Office Action Summary

10/534,600

KROLL ET AL.

Claim Rejections - 35 USC § 103

FIG. 67

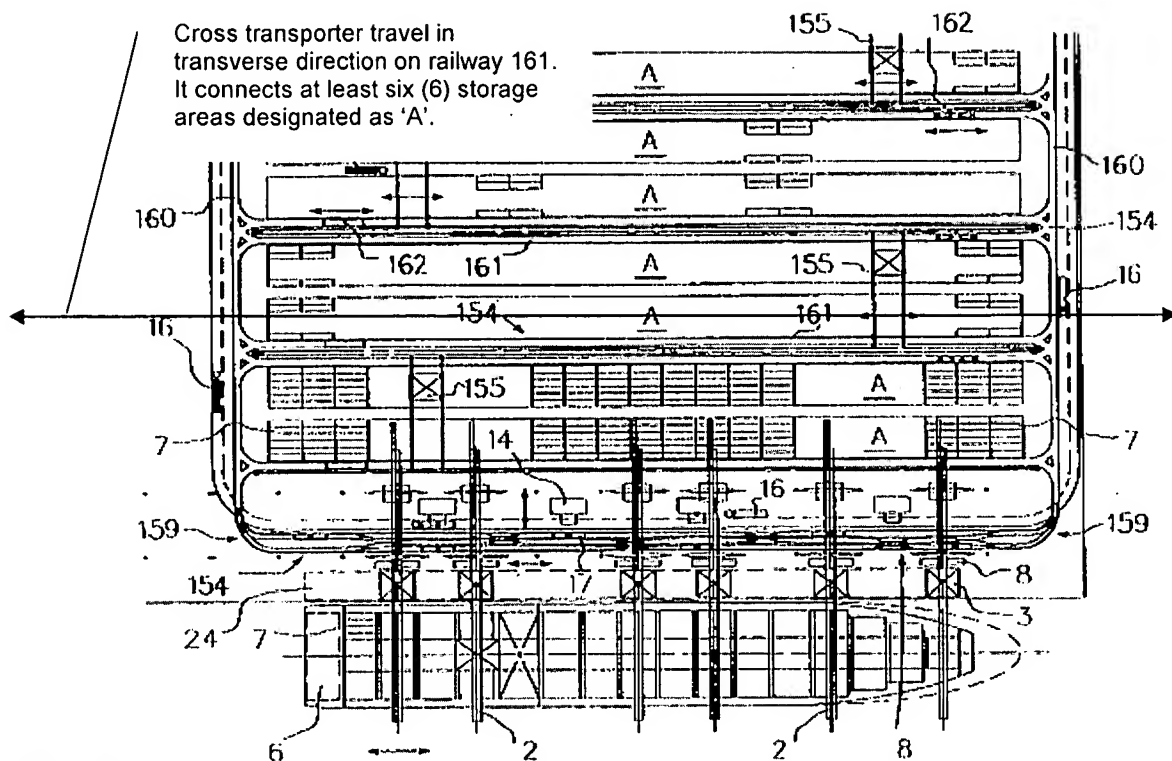
- at least one elevated stacking crane 155 per storage module;
- cross transporters 162 acting independently of each other and able to travel on a different horizontal level transverse to the individual storage modules;
- more than two cross transporters 162 being adapted to move on a same level 154 beneath a transport level of an elevated stacking crane 155 and above truck loading lanes (indicated generally as 16) and on at least one railway (FIG. 67: 161) extending transversely to storage modules into a region of interim storage stations (FIG. 67: A) assigned to each storage module A, each interim storage station being arranged sideways and parallel to railway 161 and forming interfaces between an elevated stacking crane 155 and cross transporters 162. (See also FIG. 67 reproduced below.)

Fantuzzi does not disclose an interim storage. Dobner et al. discloses interim storage stations 23, 29, e.g. buffer stores, that functionally operate to interface between a cross transporter 31 and stacking cranes while located on a level (indicated generally as 30.1) below stacking cranes. Dobner et al. teach that by virtue of the buffer stores "the arrival rate and service rate of the piece goods which are to be transferred are isolated from one another, with the result that rapid transfer is ensured. The multi-level structural arrangement of the loading installation makes it easier to observe the relevant safety regulations since loading regions and traveling regions for the manual means of transport are precisely demarcated. C2/L5-15. Therefore, it would have been obvious to one having ordinary skill in the art at the time the invention was made to modify the apparatus of Fantuzzi to include an interim storage station, as per the teachings of Dobner et al., to improve rapid transfer and safety regulations.

In response adapting an overhead crane and a cross transporters to load/unload containers from an interim storage location, a recitation of the intended use of the claimed invention must result in a structural difference between the claimed invention and the prior art in order to patentably distinguish the claimed invention from the prior art. If the prior art structure is capable of performing the intended use, then it meets the claim. In this case, a crane can lift/raise or deposit containers onto Dobner's buffer 23, 29 and either Fantuzzi's transporter or Dobner's transporter can accept containers during transfer by virtue of its horizontal surface. Thus, the cited prior art is clearly functionally able to perform as required in claim 1.

In response adapting an overhead crane and a cross transporters to load/unload containers from an interim storage location, a recitation of the intended use of the claimed invention must result in a structural difference between the claimed invention and the prior art in order to patentably distinguish the claimed invention from the prior art. If the prior art structure is capable of performing the intended use, then it meets the claim. In this case, a crane can lift/raise or deposit containers onto Dobner's buffer 23, 29 and either Fantuzzi's transporter or Dobner's transporter can accept containers during transfer by virtue of its horizontal surface. Thus, the cited prior art is clearly functionally able to perform as required in claim 1. Fantuzzi's rail system comprises elements 161, 158, 159 & 160 which allows transporters 162 to circumvent the entire of the storage modules indicated as A in FIG. 67.
